| Application No.: 98105185.5 | Applicant: SHARP KABUSHIKI KAISHA |
| Title: FRONT-ILLUMINATING DEVICE AND A REFLECTION-TYPE LIQUID CRYSTAL DISPLAY USING SUCH A DEVICE | |

NOTICE ON THE FIRST OFFICE ACTION

FIRST OFFICE ACTION

图4

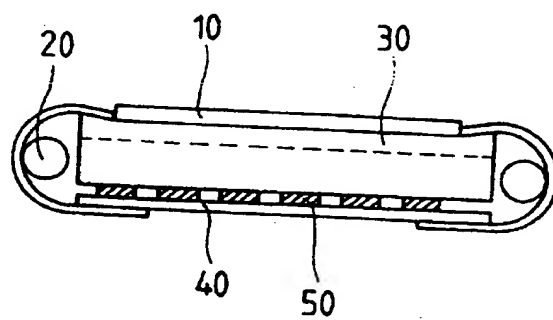
A feature added to claim 9 are such that "the second light-directing body is a light-diffusing body that diffuses light from the first light-releasing surface of the first light-directing body", and the feature is disclosed in Document 2 (see page 4, lines 2 to 8 and Fig. 4 of the specification). Further, the feature disclosed in Document 2 exhibit such an effect that the luminance distribution of the reflected light is averaged. Thus, in a case where claim 2 on which claim 9 is dependent has no inventive step, the technical ideas

A feature added to claim 11 is such that "the light diffusing body is a front-diffusing body", and the feature is disclosed in Document 2 (see page 4, lines 2 to 8 and Fig. 4 of the specification). Further, the feature disclosed in Document 2 exhibits such an effect that the luminance distribution of the reflected light is averaged. Thus, in a case where claim 9 on which claim 11 is dependent has no inventive step, the technical ideas recited in claim 11 has no outstanding feature and no distinct progress, so that claim 11 does not have inventive step defined in Section 22 Paragraph 3 of the Patent Law.

A feature added to claim 17 is such that "the front-illuminating device further includes a light-converging means for allowing light from the light source to be made incident only on the incident surface", and the feature is disclosed in Document 2 (see page 4, lines 2 to 8 and Fig. 4 of the specification). Further, the feature disclosed in Document 2 exhibits such an effect that the

对比文件 2 (CN1087180A) 是一篇涉及技术领域与该申请涉及的技术领域相同的文献,并披露了权利要求 2 的附加技术特征(说明书第 4 页第 2 行至第 8 行及附图 4):将其光导体作为第 1 光导体(30),进而具有使上述第 1 放射面的放射光的亮度分布均匀化的第 2 光导体(10)。上述技术特征在对比文件 2 中所起的作用是为了克服光照不均匀性,这与上述技术特征在权利要求 2 请求保护的技术方案中所起的作用相同,即对比文件 2 给出了将上述技术特征应用于对比文件 1 中以进一步解决其技术问题的启示。因而由于其引用的权利要求 1 不具有新颖性,权利要求 2 请求保护的技术方案不具有突出的实质性特点和显著的进步,不符合专利法第二十二条第三款有关创造性的规定,不具有创造性。

权利要求 9 的附加技术特征为:所述第 2 光导体是使来自第 1 光导体的第 1 放射面的放射光散射的光散射体。对比文件 2 也公开了上述技术特征(说明书第 4 页第 2 行至第 8 行及附图 4),且上述技术特征在对比文件 2 中所起的作用是为了使放射光的亮度均匀分布,这与上述技术特征在权利要求 9 请求保护的技术方案中所起的作用相同。因而由于其引用的权利要求 2 不具有创造性,权利要求 9 请求保护的技术方案不具有突出的实质性特点和显著的进步,不符

权利要求 11 的附加技术特征为: 上述光散射体是前方光散射体。对比文件 2 也公开了上述技术特征(说明书第 4 页第 2 行至第 8 行及附图 4), 且上述技术特征在对比文件 2 中所起的作用使放射面的放射光亮度均匀分布, 这与上述技术特征在权利要求 11 请求保护的技术方案中所起的作用相同。因而由于其引用的权利要求 9 不具有创造性, 权利要求 11 请求保护的技术方案不具有突出的实质性特点和显著的进步, 不符合专利法第二十二条第三款有关创造性的规定, 不具有创造性。

权利要求 20 的附加技术特征为: 该装置具有使光源光仅向上述入射面入射的聚光装置。对比文件 2 也公开了上述技术特征(说明书第 4 页第 2 行至第 8 行及附图 4), 且该技术特征在对比文件中所起的作用是使提高光源放射光的利用率, 这与该技术特征在权利要求 20 请求保护的技术方案中所起的作用相同。因而由于其引用的权利要求 1 不具有新颖性, 权利要求 20 请求保护的技术方案不具有突出的实质性特点和显著的进步, 不符合专利法第二十二条第三款有关创造性的规定, 不具有创造性。
